2024-09-11 CONCEPT TRC MEETING:

CONSTRUCTION DRAWINGS
DEERCREST SEAFORTH
SEAFORTH ROAD, PITTSBORO, NC 27312
CHATHAM COUNTY

PRELIMINARY PLAT

SHEET #: C-1.3A

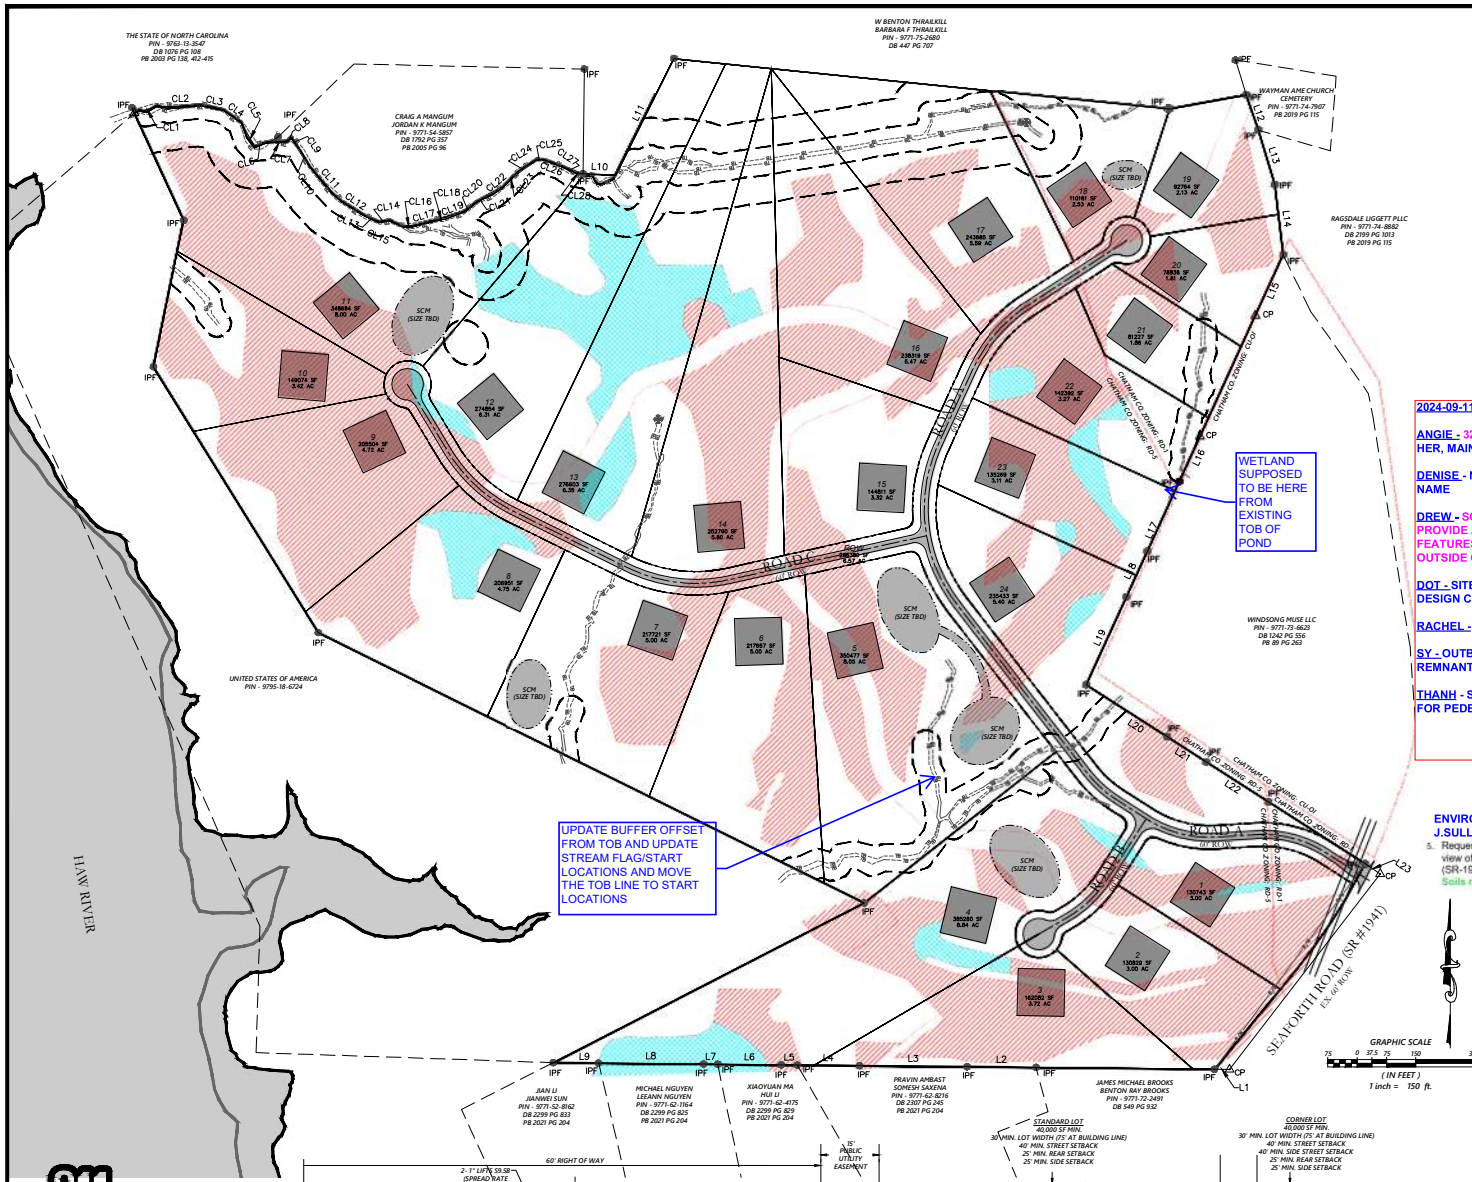
ANGIE - 32 SQFT OF SIGN AREA, PERMIT SIGN/STREET LIGHTING WITH HER, MAINTENANCE AREAS VS HOME CONSTRUCTION

DENISE - NEED ROAD NAMES AND MAIN ROAD WILL BE SUB-DIVISION NAME

DREW - SCM WITH EASEMENTS AND OUT OF BUFFER, WIDE ENOUGH TO PROVIDE ACCESS AND MAINTENANCE, TOP BANK LINES OUTSIDE OF FEATURES CAN BE TRIMMED REMOVED, MAKE SURE ALL SEPTIC AREAS OUTSIDE OF RIPARIAN BUFFERS,

DOT - SITE DISTANCES AND SITE TRIANGLE, DESIGN PER CURRENT DESIGN CRITERIA

SY - OUTBUILDING OR STRUCTURE FROM 1938 AND SEE IF ANY REMNANTS

THANH - SIDEWALKS? IF BLIND SPOTS....POSSIBLE INCLUSION OF SIGNS FOR PEDESTRIANS AT BLIND SPOTS

5. Request Chad Abbott, P.E. on behalf of Seaforth Road , LLC for subdivision **Concept Plan** review of **Deercrest at Seaforth**, consisting of 32 lots on 110.48 acres, located off Seaforth (SR-1941) Road, parcel 62077.
Soils map appears to indicate enough suitable soil for the desired number of lots.
